CHAPTER 500 STAKEHOLDER ENGAGEMENT | TECHNICAL COMMITTEE MEETING #7 MINUTES

RE: Chapter 500 Stakeholder Engagement, Technical Committee Meeting #7

DATE: Thursday, December 12, 2024

Figure 3. Runoff volume reduction performance curve for infiltration trenches for the Example Project in Scarborough.

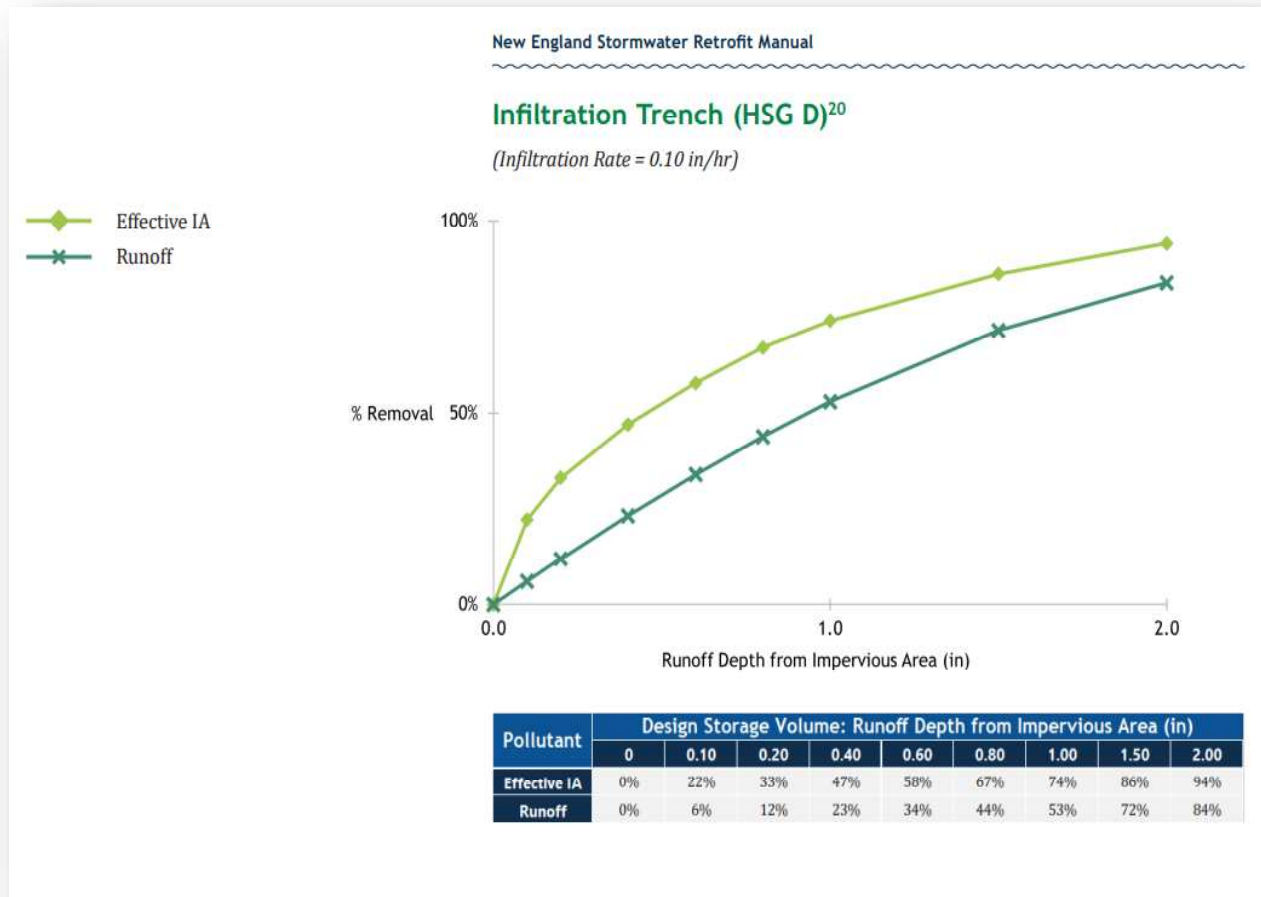
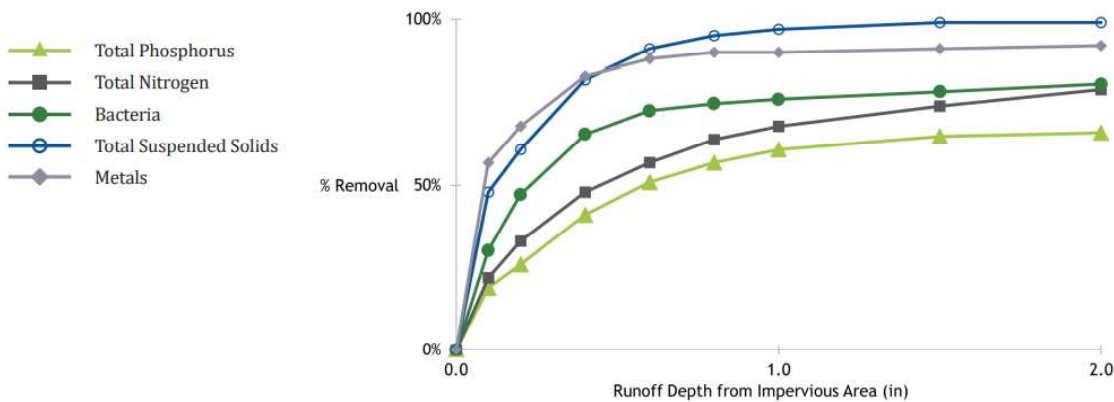
- Figure 3 (Appendix). Assuming site is HSG
 - In long memo, required runoff volume reduction is 35
- Figure 1 in Appendix, Karem walked through each of the standards to apply them to the new hotel in Scarborough.

- HSG for the site is A/D. The soil is very loose fine to coarse sand with a seasonal high water table at 2 feet below the surface. The site is also relatively flat, making it difficult to achieve the proper head for conveying stormwater runoff.

- Because of the site constraints, this may be a situation where a waiver from strict adherence is needed. First we attempt to infiltrate the roof runoff. It must be noted that the new General Standards do not require rooftop runoff treatment for nitrogen or phosphorus removal. Thus, the separation to the seasonal high water table can be reduced to one foot. Potential alternatives for meeting the runoff volume reduction for the roof:

- Roof drip-edge filters
 - Approximate building perimeter = 600 feet. Rock porosity = 0.4. Depth = 1 ft (to maintain at least 1 feet separation from SHWT). Required width to achieve the 750 cubic feet storage (calculated below) = 3.2 ft wide system. This assumes no underdrain (frost depth issue). Overflow would spill over the filter edge.
